# **Land East of Lunce's Common, Haywards Heath**

Stage 1 Road Safety Audit  
Designer's Response Report

**Land East of Lunce's Common, Haywards Heath  
Stage 1 Road Safety Audit - Designer's Response Report**

## **Appendix B Problem Location Plan**

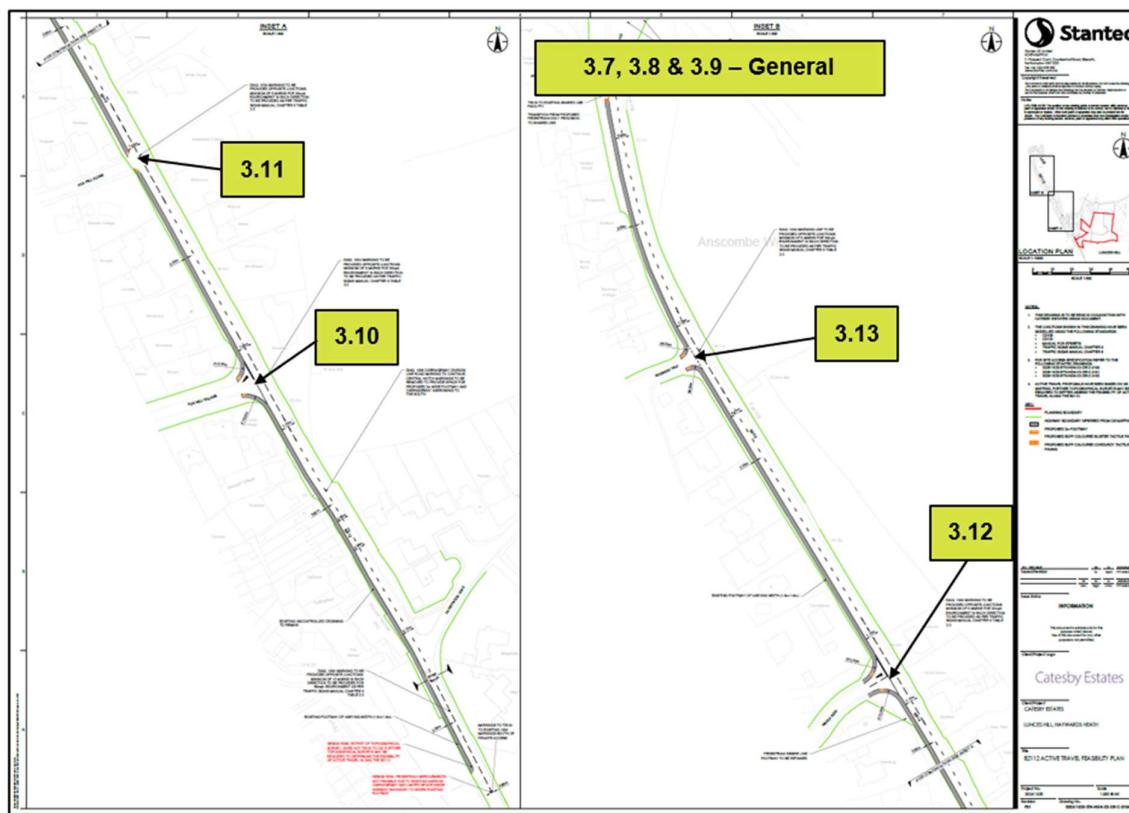
- 1.2.1 This report lists road safety problems identified by the Stage 1 RSA. The responses from the Design Team are indicated in bold typeface.
- 1.2.2 Problems identified in this report are indicated by location and are shown on the site reference plan in **Appendix A**.

## Appendix C     **Visibilities Drawing**

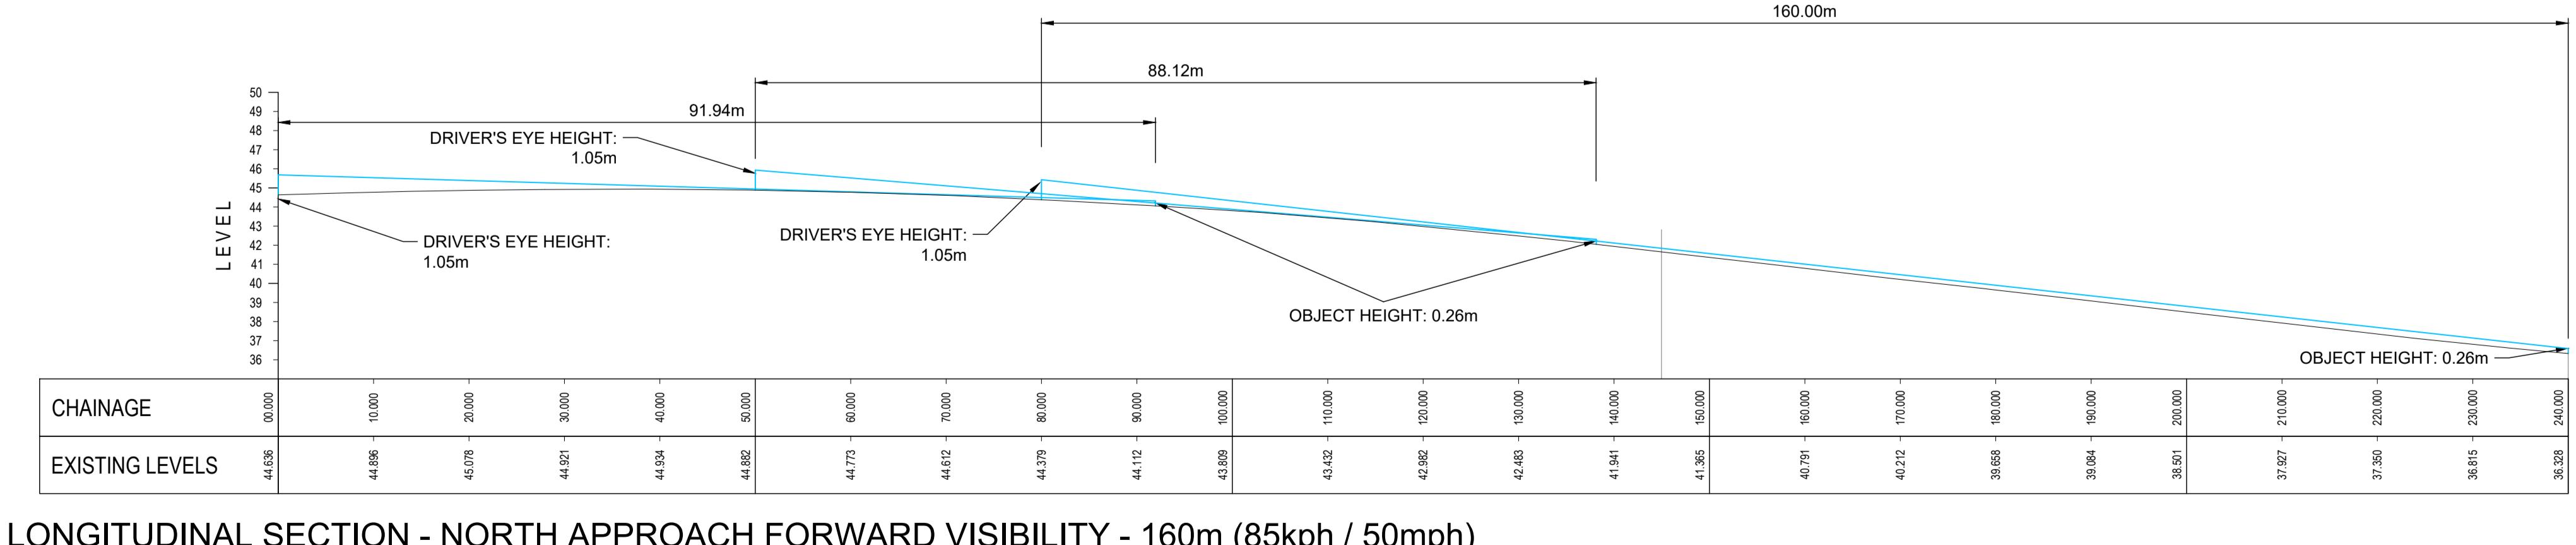
Road Safety Audit Decision Log				
RSA Problem	RSA Recommendation	Design Organisation Response	Overseeing Organisation Response	Agreed RSA Action
<b>3.1</b>  <b>Location:</b> Lunce's Hill; Site Access Junction  <b>Summary:</b> Insufficient visibility may lead to pull-out type vehicle collisions.  Visibility to the left for road users waiting at the give way line of the site access to pull-out onto Lunce's Hill is likely to be reduced by the dense vegetation within the eastern verge. Insufficient visibility may lead to pull-out type vehicle collisions.	An adequate visibility splay should be provided, with vegetation cleared within the splay envelope.  It is assumed that the gateway signs will be relocated as part of the gateway feature. This should be clarified at detailed design stage.	Noted and agreed – to be picked up at the detailed design and technical approval stage.  Drawing 332611520-STN-HGN-XX-DR-C-0102 P06 shows the visibilities at the site access, and a note has been added to the drawing regarding vegetation cut back required for the visibility splays to ensure it is picked up at the next design stage.

## Appendix D    Site Access Drawing

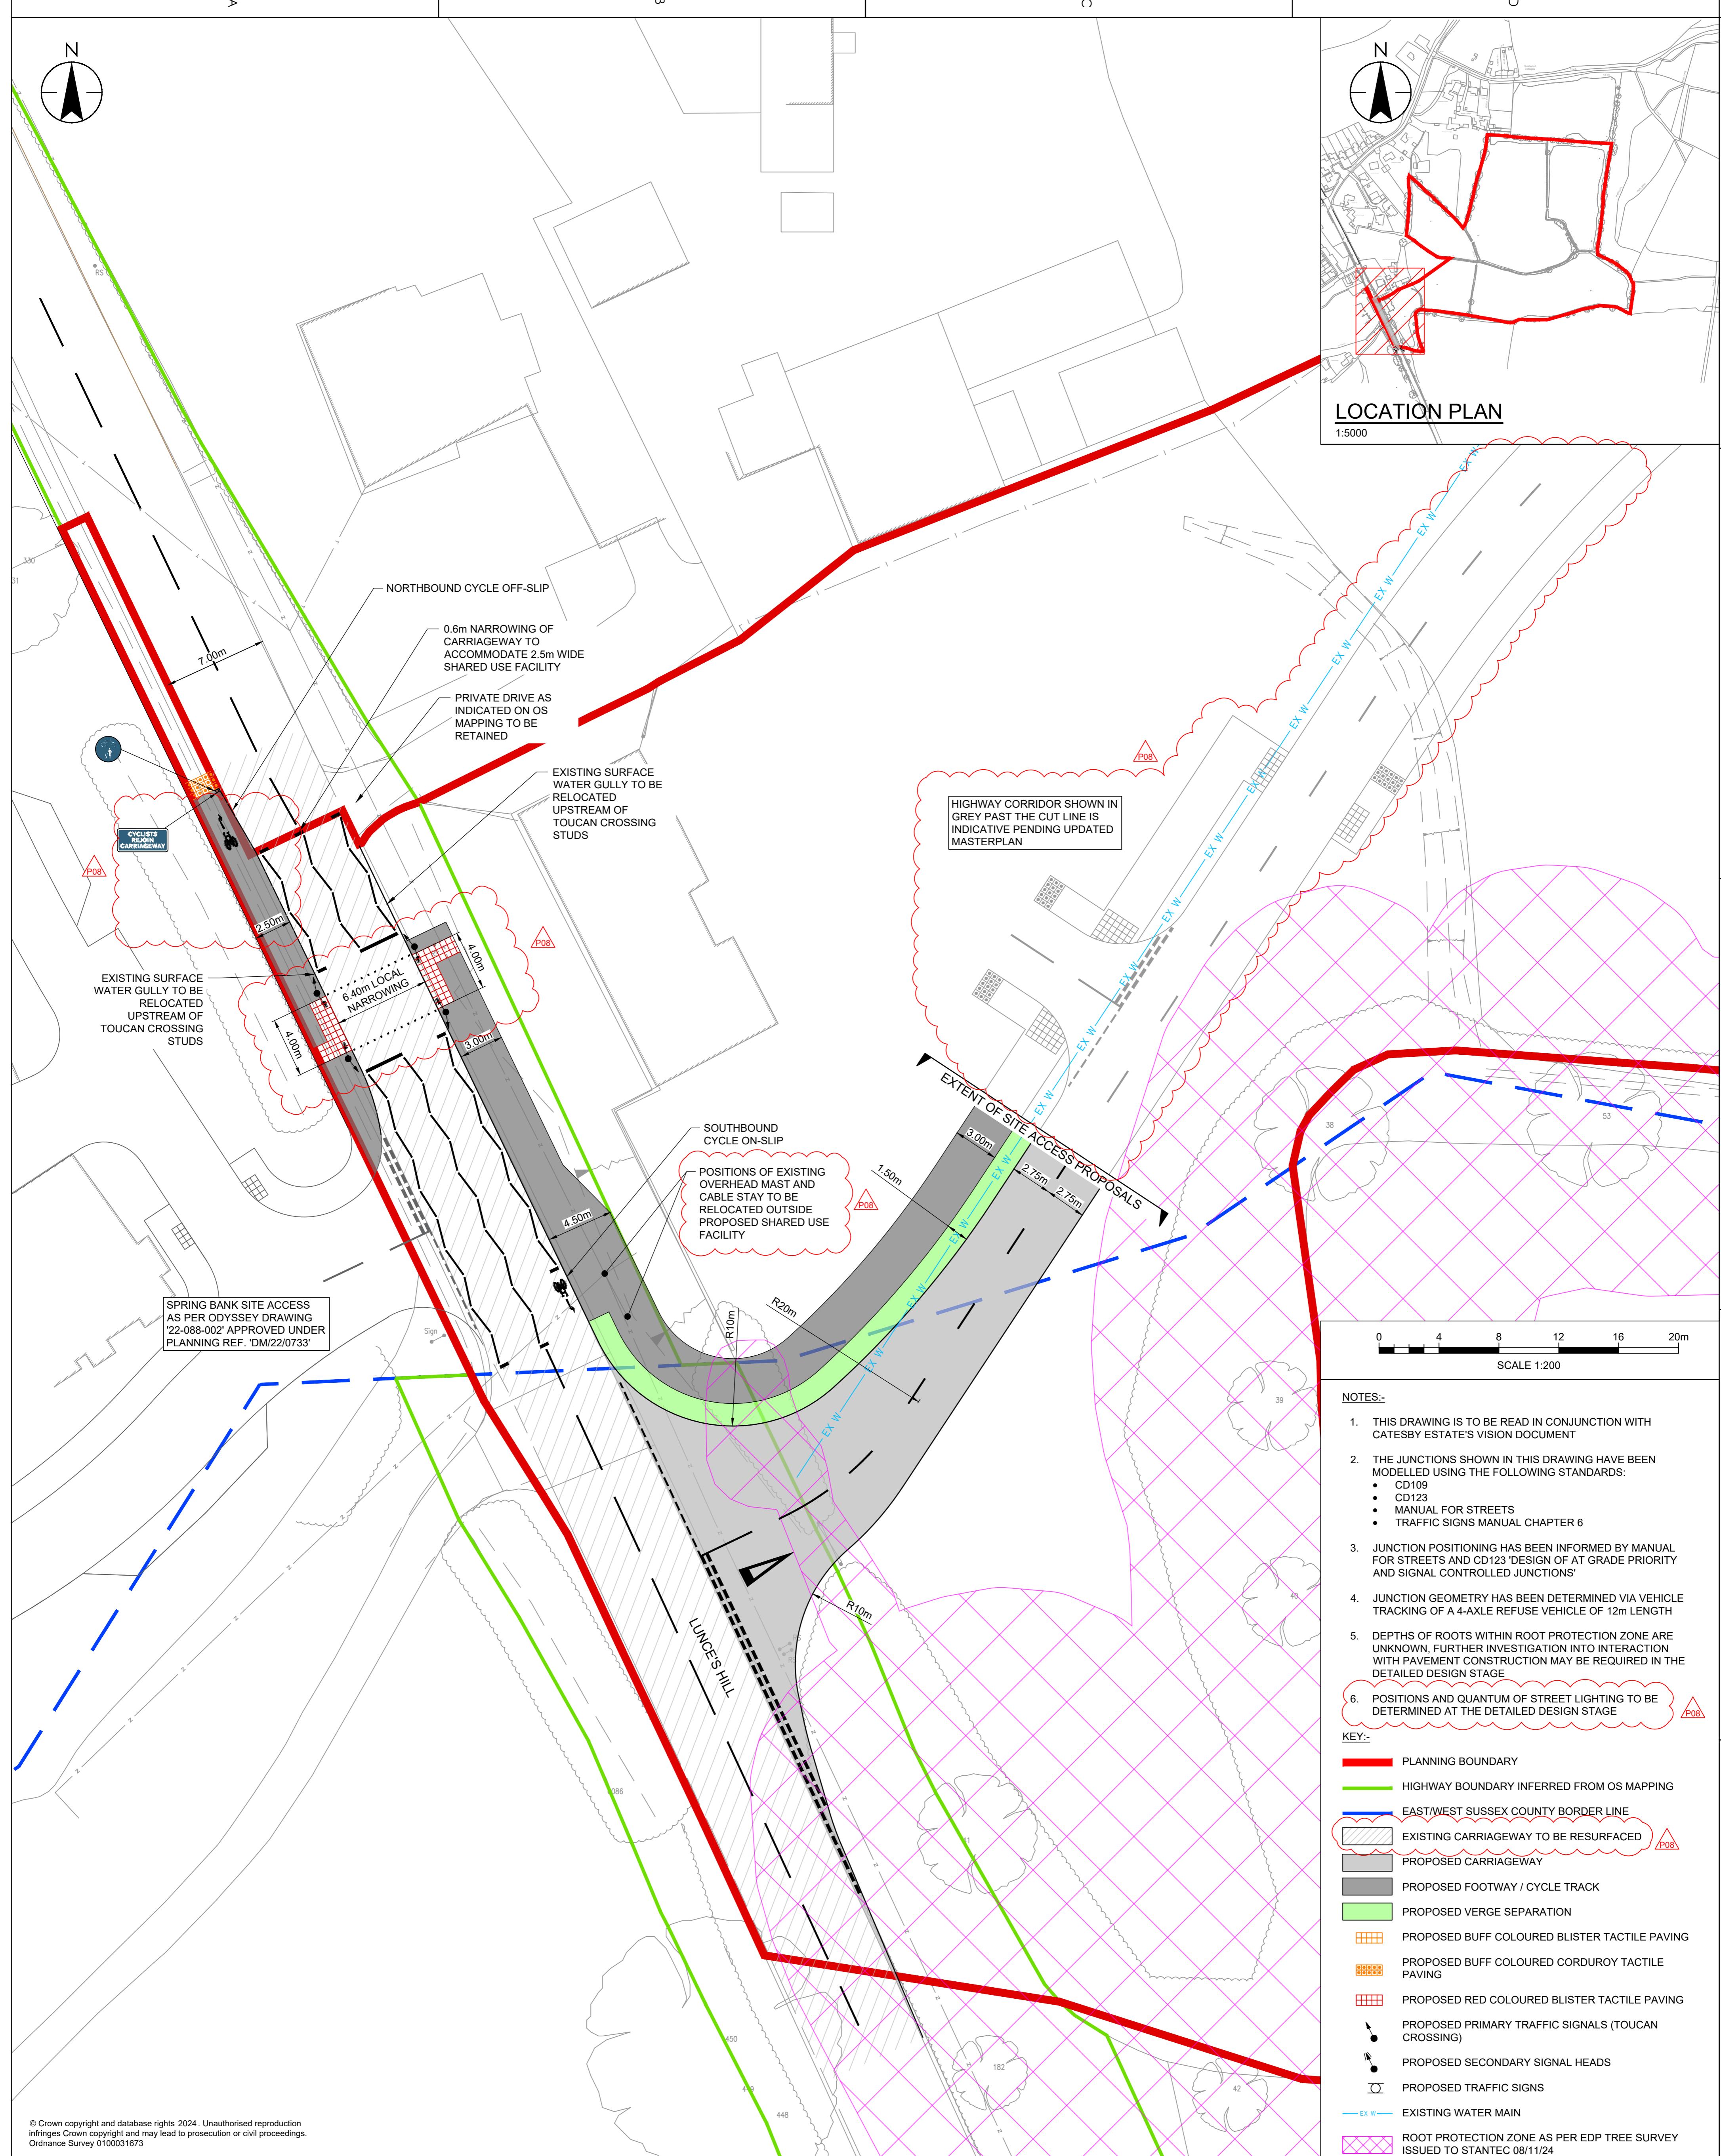
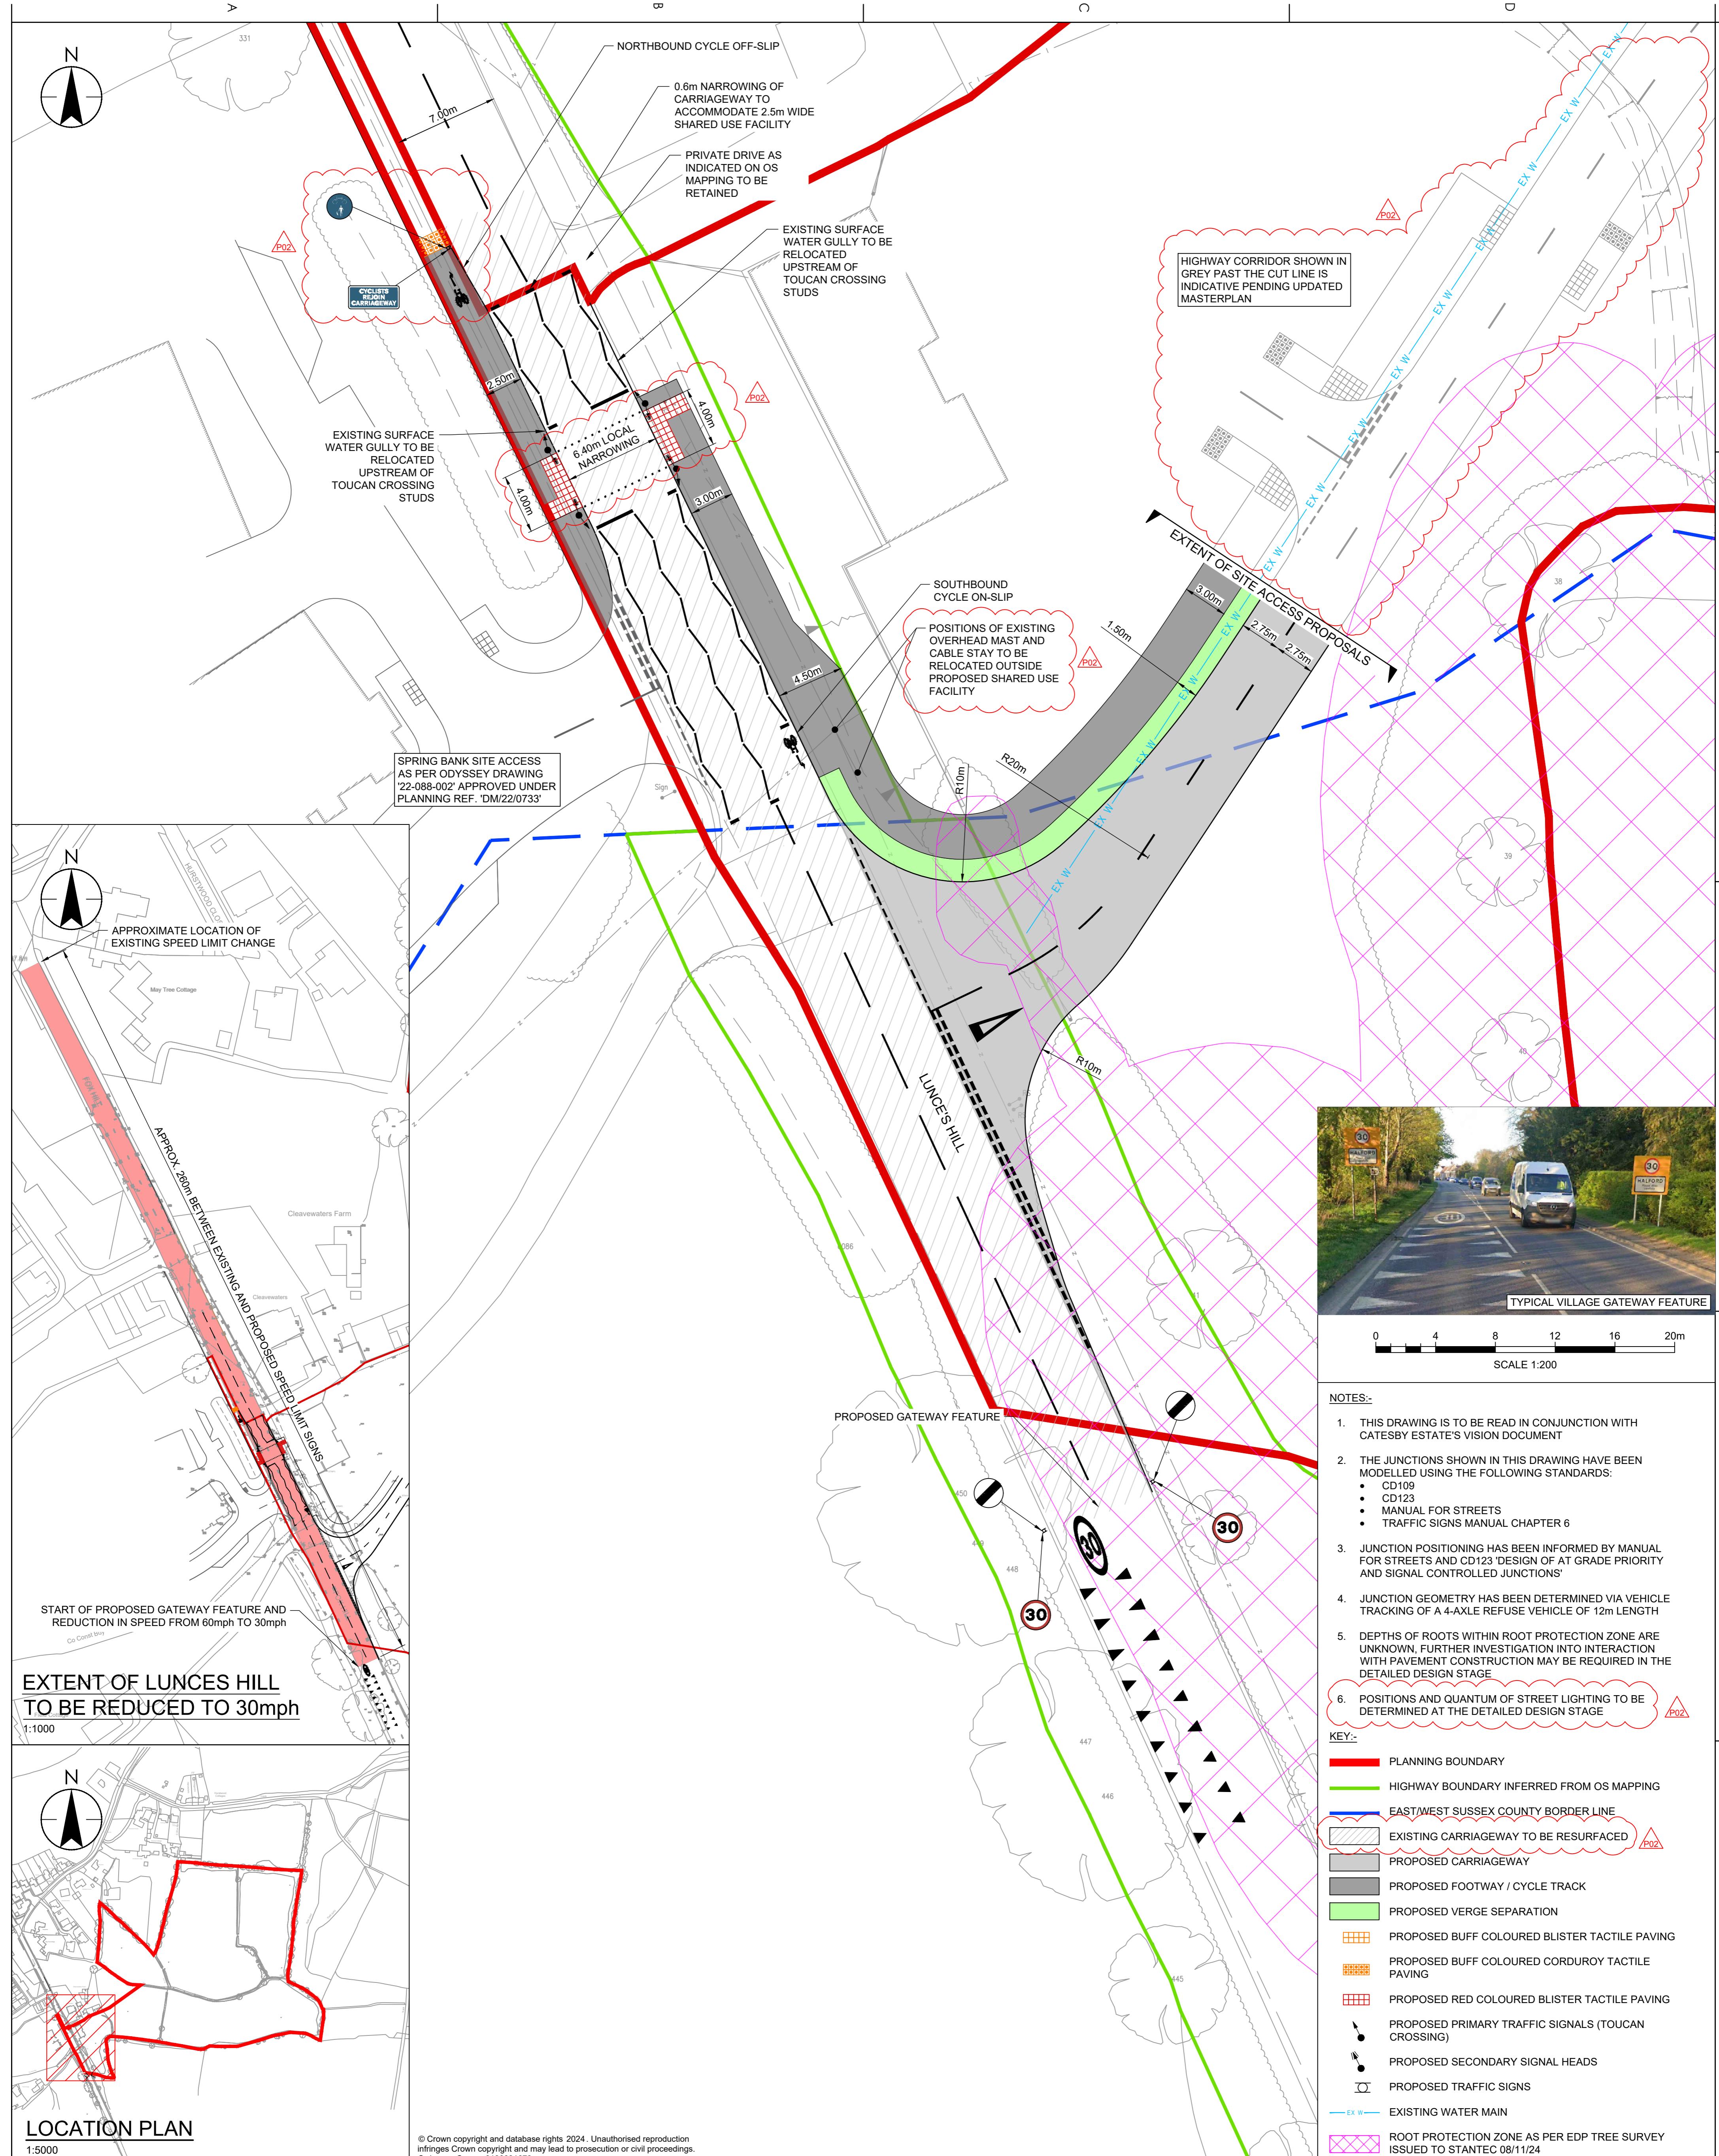
*"I have reviewed the updated drawing that you sent through (C-0103 P02) and I can confirm that we do not have any additional safety comments to raised in relation to the widened toucan crossing and other minor design changes."*

<b>3.2</b>  <b>Location:</b> Lunce's Hill; Site Access Junction and Toucan Crossing  <b>Summary:</b> Poor carriageway surface may lead to skid and loss of control type collisions (junction) and late braking and overshoot collisions with pedestrians / cyclists at the toucan crossing.  The existing carriageway surface on Lunce's Hill at the proposed site access junction and toucan crossing is poor with evidence of surface cracking and a patchy surface that will likely have varied skid resistance. The poor	Lunce's Hill should be resurfaced to cover the site access junction and toucan crossing (it is generally recommended that a PSV of 68+ is provided on approaches to a light controlled pedestrian crossing).	Noted and agreed – to be picked up at the detailed design and technical approval stage.  This has been shown on drawing revisions 332611520-STN-HGN-XX-DR-C-0100 P08 and 332611520-STN-HGN-XX-DR-C-0103 P02 as a hatched area of carriageway and referenced in the key to ensure it is picked up at the next design stage.

Road Safety Audit Decision Log				
RSA Problem	RSA Recommendation	Design Organisation Response	Overseeing Organisation Response	Agreed RSA Action
carriageway surface may lead to skid and loss of control type collisions (junction) and late braking and overshoot collisions with pedestrians / cyclists at the toucan crossing.				
<b>3.3</b>  <b>Location:</b> Lunce's Hill; Site Access Junction and Toucan Crossing  <b>Summary:</b> Insufficient illumination may lead to darkness related collisions between all road users.  Other than a singular streetlight (parish lighting) there is no other illumination on Lunce's Hill at the proposed site access junction and toucan crossing. Where new vehicle turning manoeuvres and pedestrian / cycle activity is to be introduced, insufficient illumination may lead to darkness related collisions between all road users.	A suitable system of street lighting should be provided at detailed design stage.	<p>Noted and agreed – street lighting will be picked up at the detailed design and technical approval stage.</p> <p>This has been referenced on drawing revisions 332611520-STN-HGN-XX-DR-C-0100 P08 and 332611520-STN-HGN-XX-DR-C-0103 P02 as Note 6 to ensure it is clear and picked up at the next stage of design work.</p>

<b>3.4</b>  <b>Location:</b> Lunce's Hill; Shared Use Footway / Cycleway  <b>Summary:</b> Street furniture in the footway may be a potential hazard and obstruction to pedestrians and cyclists.	At detailed design stage the telegraph pole and cable stays should be relocated out of the shared use facility.	<p>Noted and agreed – to be picked up at the detailed design and technical approval stage.</p> <p>This has been referenced on drawing revisions 332611520-STN-HGN-XX-DR-C-0100 P08 and 332611520-STN-HGN-XX-DR-C-0103 P02 to ensure it is clear and picked up at the next stage of design work.</p>

<b>3.14</b>  <b>OBSERVATION:</b>  The scheme proposed to introduce a new 30mph speed limit (down from national speed – 60mph) including the provision of a new gateway feature just to the south of the proposed site access junction on Lunce's Hill. However, it was noted on site that there is already a 30mph speed limit on this section,		<p>Noted that the 30mph speed limit extension has already been introduced.</p> <p>The site access option drawing showing the proposed speed limit extension has not been updated to reflect the actual location as this is currently unclear without topographical survey data. However, the site would still propose introducing the same gateway features identified in Drawing 332611520-STN-HGN-XX-DR-C-0103 P02 at the new speed</p>

I have reviewed the updated drawing that you sent through (C-0103 P02) and I can confirm that we do not have any additional safety comments to raised in relation to the widened toucan crossing and other minor design changes.

P08_UPDATES FOLLOWING TMS STAGE 1 RSA	BB	DL	2025.09.30
P07_AT/ON/NEAR TOUCAN ACCESS PLAN	BB	NP	2025.07.21
P06_SCALE BAR ADDED	BB	NF	2025.03.05
P05_UPDATED SITE BOUNDARY	BB	NF	2025.01.13
P04_RELLOCATION OF PUFFIN CROSSING	BB	NF	2024.12.13
P03_NARROWING OF EDGE PROVING MAP	BB	MH	2024.11.19
P02_REALIGNMENT FOLLOWING TREE SURVEY	BB	MH	2024.11.13
P01_FIRST ISSUE	BB	MH	2024.08.23
Issued/Revision	By	Appld	YYYY.MM.DD
